# CBX25UH and CBX25UHV Air Handler Enhancement

## Additional Technical Changes

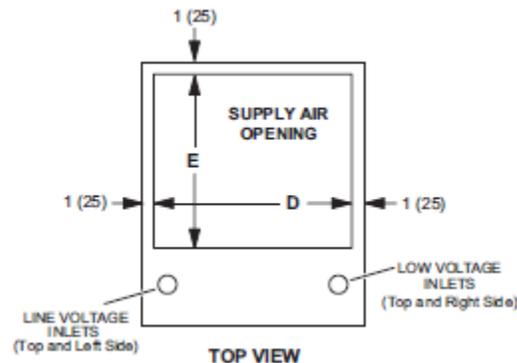
- The height of the 3 Ton CBX25UH will increase to 52.5 inches from its current 48 inches. As a result, a new catalog number will be made available for this unit. Information on this new catalog number will be forthcoming. No other catalog numbers will be changed.
- The depth of the supply air opening on both the CBX25UH and CBX25UHV has been changed to the following dimensions.

018		024		030		036		042		048-060	
Dimension		in.	mm	in.	mm								
Original	Depth (E)	17	432	17	432	17	432	17	432	21	533	21	533
	Width (D)	13	330	16-1/2	419	16-1/2	419	19-7/8	505	19-7/8	505	19-7/8	505
New	Depth (E)	14-1/2	368	14-1/2	368	14-1/2	368	14-1/2	368	18-3/4	476	18-3/4	476
	Width (D)	13	330	16-1/2	419	16-1/2	419	19-7/8	505	19-7/8	505	19-7/8	505
